The Secretary
NSW Planning, Industry & Environment

24 March 2020

I refer to the Department's below email of 12 March 2020 regarding the exhibition of the Environmental Impact Statement (EIS) for State Significant Development SSD-10404 at Cowpasture Road and Trivet Street, Wetherill Park within the Fairfield LGA (Lots 17-23 DP 13961) for Horsley Drive Stage 2 - Building 1 being for 'Construction & 24 hr operation of a warehouse for receipt, storage, handling & distribution of food & groceries associated with online retail, office premises, areas for parking, load/unloading of delivery vehicles, landscaping & infrastructure'. Submissions need to be made to the Department by 17 April 2020.

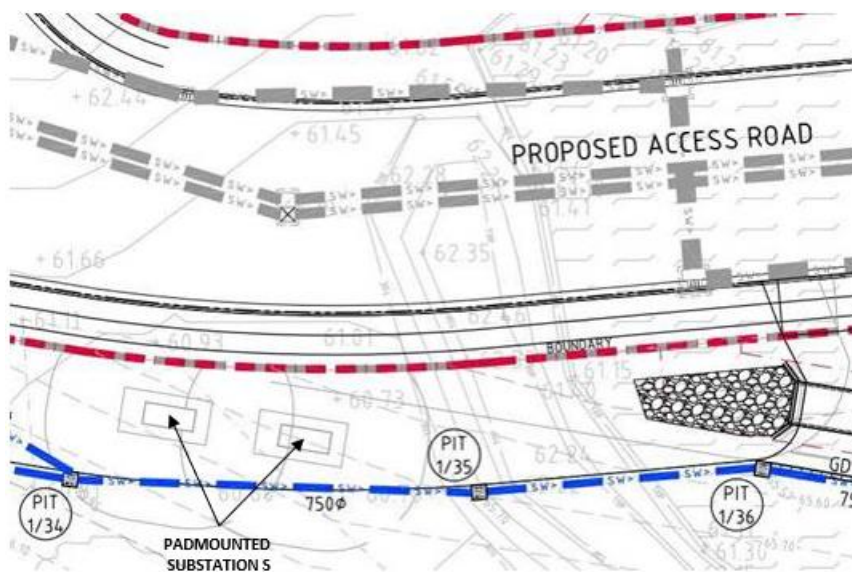
There have previously been enquiries for industrial subdivision and establishment of warehouse(s) in the highlighted area included in this EIS but to date these have not proceeded.

Endeavour Energy has spare capacity from the nearby West Wetherill Park Zone Substation from which a new 11 kV feeder may be required depending on the size and type of the load application.

The development may require the existing overhead power lines to be undergrounded along the frontage.

A method of supply will be provided via Network Connections Branch when a load application is received.

A4.3 - Padmount easements and clearances

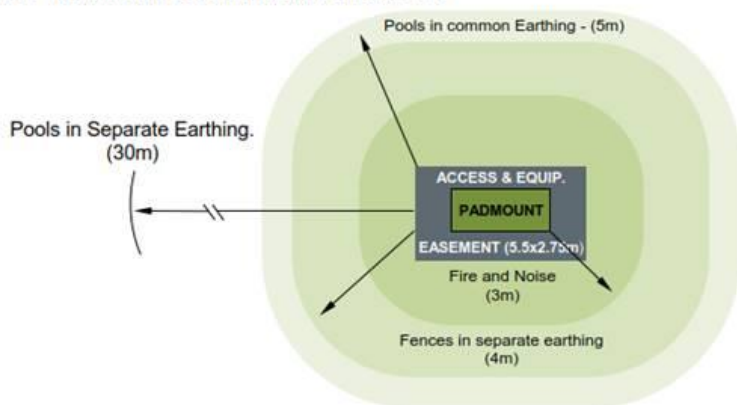
Regarding the padmount substation/s required to facilitate the proposed development (which do not appear to be shown on the Attachments A & B Plans), Endeavour Energy's general requirements is for a padmount substation to be at ground level and have direct access from a public street (unless provided with a suitable easement for right of access). It must be protected (including any associated cabling) by an easement and associated restrictions benefiting and gifted to Endeavour Energy as outlined in the attached copy of Endeavour Energy's Mains Design Instruction MDI 0044 'Easements and Property Tenure Rights'.

The padmount substation easement has a minimum size of 2.75 x 5.5 metres and must also have the additional restrictions for fire rating (which usually extends 3 metres horizontally from the base of the substation footing, and 6 metres vertically from the same point and also has regard to any structures etc. attached to the building that may spread a fire) and possibly swimming pools and spas (which extends five meters from the easement but in this instance does not appear to be applicable).

These requirements are shown in the following extract of Figure A4.3 'Padmount easements and clearances' from Endeavour Energy's Mains Design Instruction MDI 0044 'Easements and Property Tenure Rights'.

Figure 45 - Minimum FRL clearances for components

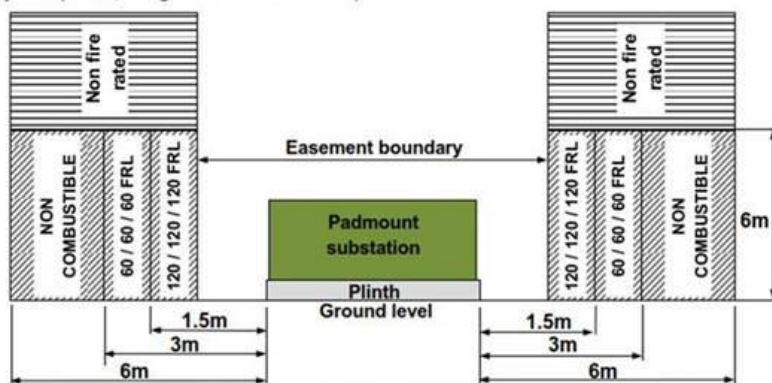
Padmount substations require separation from neighbouring areas and buildings that are subject to fire risk. Separation may be by means of adequate clearances or building components having minimum fire resistance level (FRL) as set out in Figure 45.

Fire ratings shall be achieved by static means (that is, walls or distance) rather than active system (that is, deluge showers and the like).
